ADEQUACY OF STATION ELECTRIC DISTRIBUTION SYSTEM
VOLTAGES, BEAVER VALLEY POWER STATION, UNIT NO. 1

Report No. EGG-EA-5840

Docket No. 50-334
TAC No. 13110
Draft 4/8/82

UNIT ONE LINE DIAGRAM
BEAVER VALLEY STATION
FIGURE 1

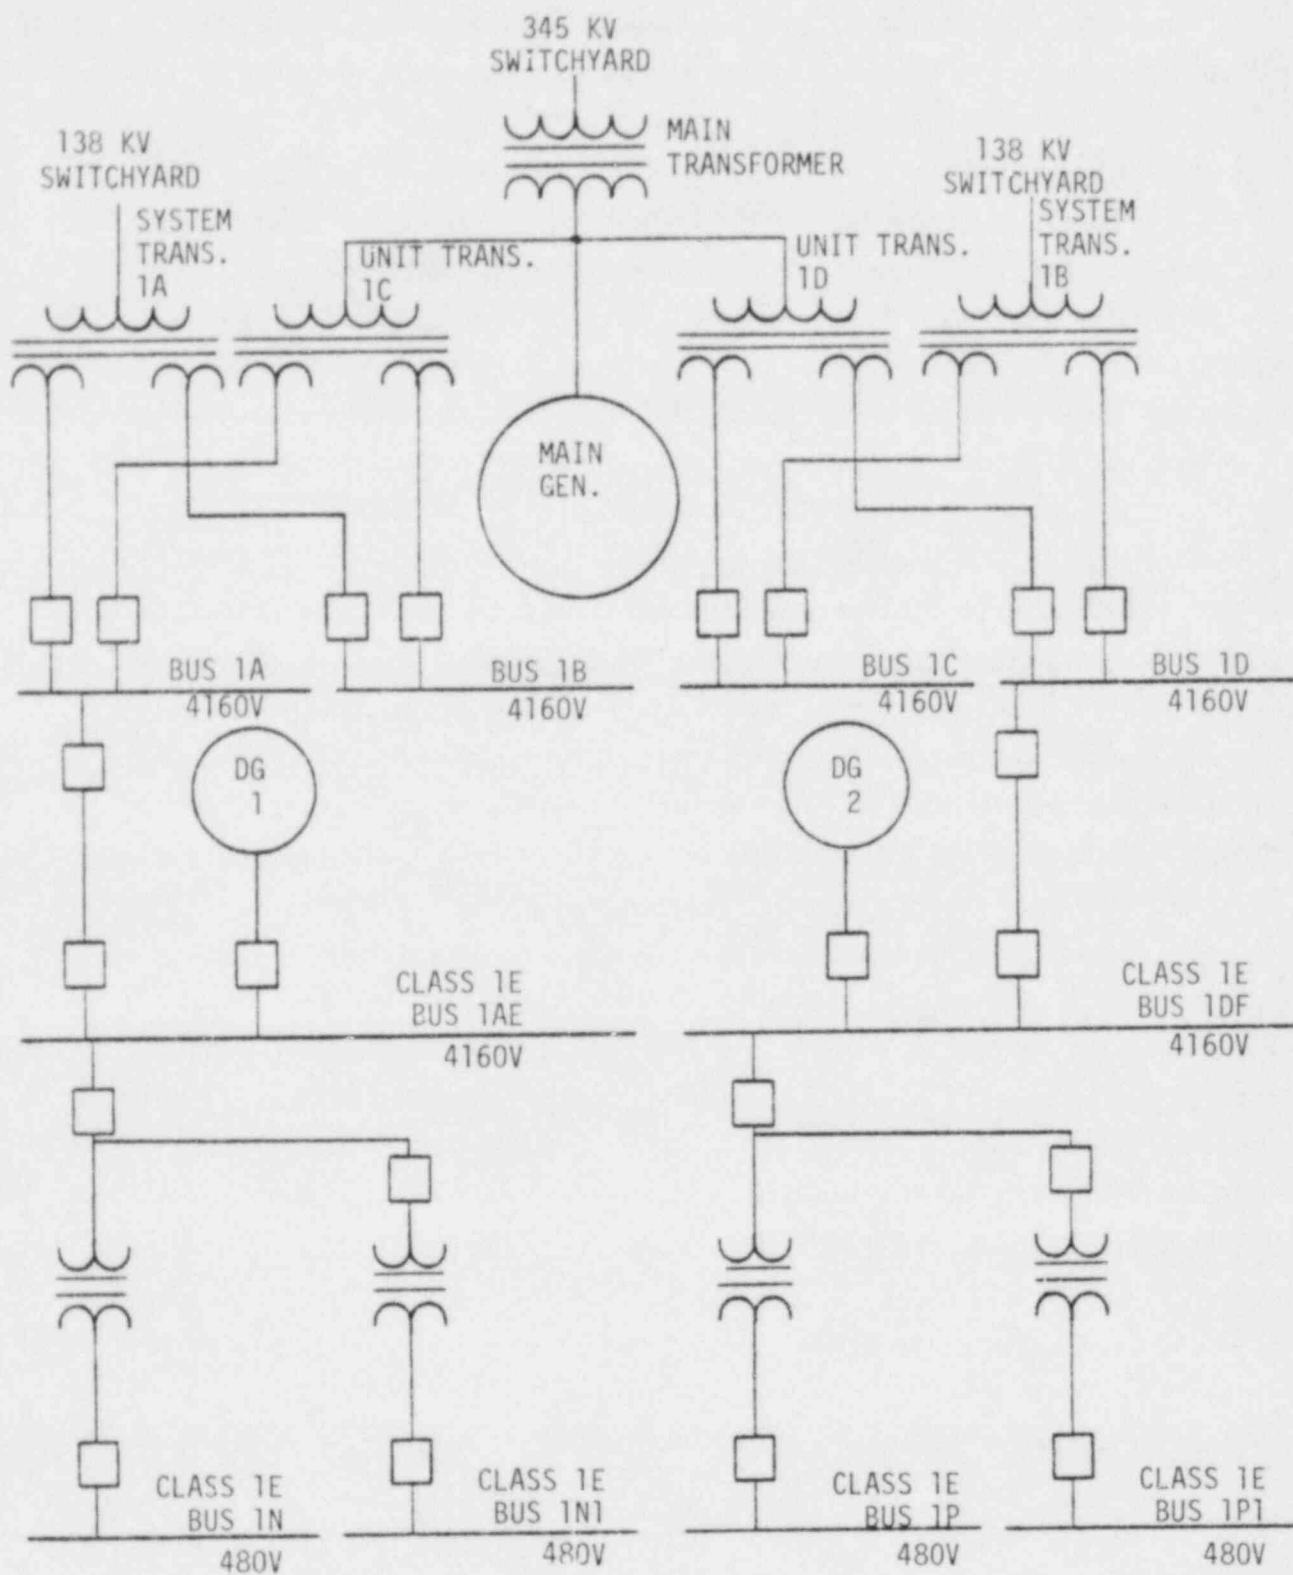
Figure 1 of this report is a unit one-line diagram of the power sources and the Class 1E distribution system taken from Figure 8.1-1 of the FSAR. Class 1E 4160V buses 1AE and 1DF are supplied power from auxiliary buses 1A and 1D, respectively. When the unit generator is operating, these buses are powered by independent unit transformers. On a unit generator trip, these buses are automatically and independently connected via separate system auxiliary transformers 1A and 1B to the 138kV switchyard. The unit generator cannot be isolated from the unit transformers; therefore, the main transformer cannot supply offsite power to the Class 1E buses from the 345kV switchyard.

Each 4160V Class 1E bus supplies power to two 480V Class 1E buses via separate 4160V/480V transformers. 120V vital buses are normally supplied power from uninterruptable power supplies (UPS), however, when a UPS is undergoing maintenance, separate 480V/120V transformers supply power to the 120V vital buses. Other 120V buses that supply instruments and control systems as required by GDC 13 are powered by 480/240/120V transformers.
